Source: Leece-Neville Heavy Duty Systems Division -
Arcade, NY USA
Date: February 28, 2006
Subject: Replacement of 8RL3021, 8RL3022 with 8RL3024
Bulletin No: TSB-1041
Models: 8RL3021, 8RL3022, 8RL3024

Technical Service
Bulletin

Replacement of 105-351 (8RL3021) and 105-352 (8RL3022) with 105-396 (8RL3024)

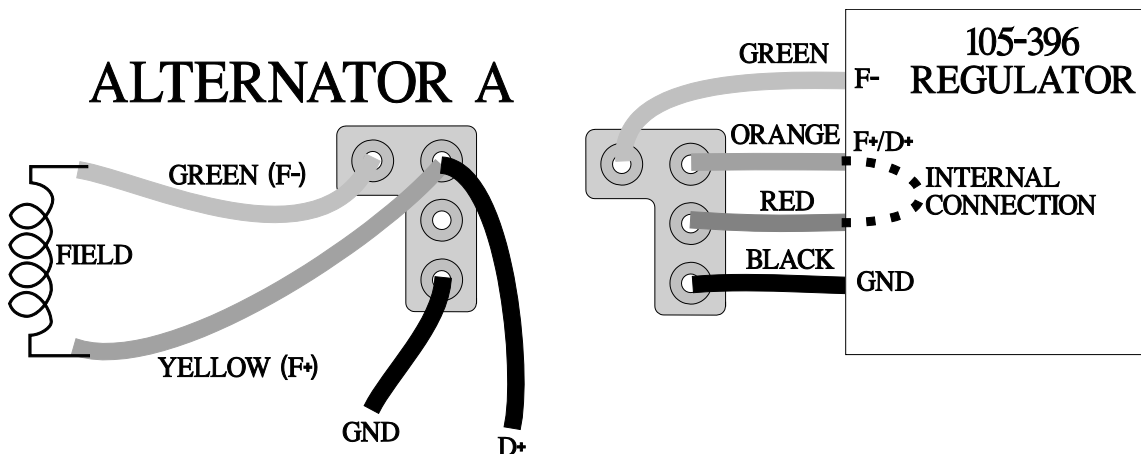
The following alternators (110-302, 110-258A, 110-316, 110-431, 110-569) referred to as **ALTERNATOR A** used a three wire regulator (105-351). The D+ signal is connected directly to the positive side of the field (F+) inside the alternator. In this configuration, the red lead from the 105-396 regulator is not used and is connected to an unused terminal.

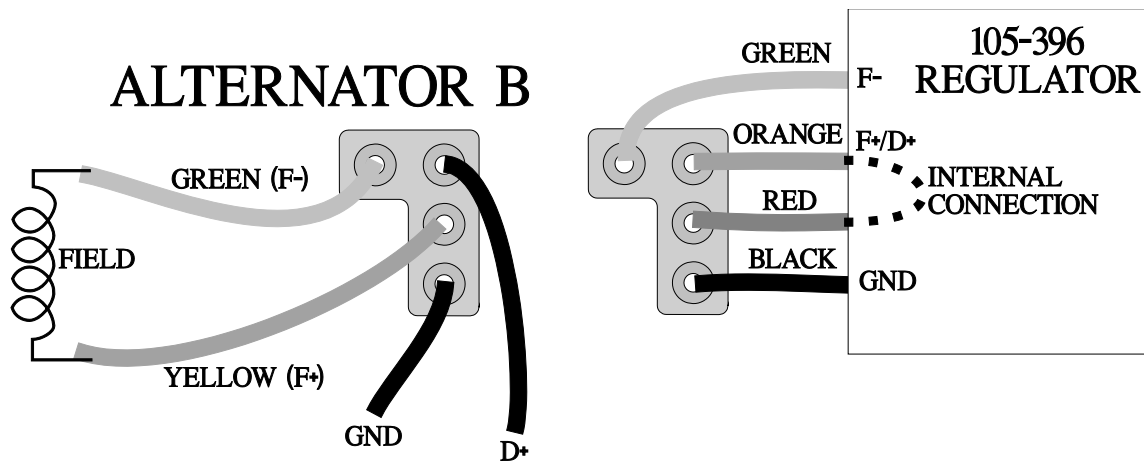
This alternator (110-298) referred to as **ALTERNATOR B** originally utilized the four wire regulator (105-352). The internal wiring of this alternator and regulator has not changed.

When installing the new regulator, use the following torques:

Terminal nuts (4)	4-7	in. lb.
Mounting screws (4)	28-33	in. lb.
Excitation nut (1)	25-30	in. lb.
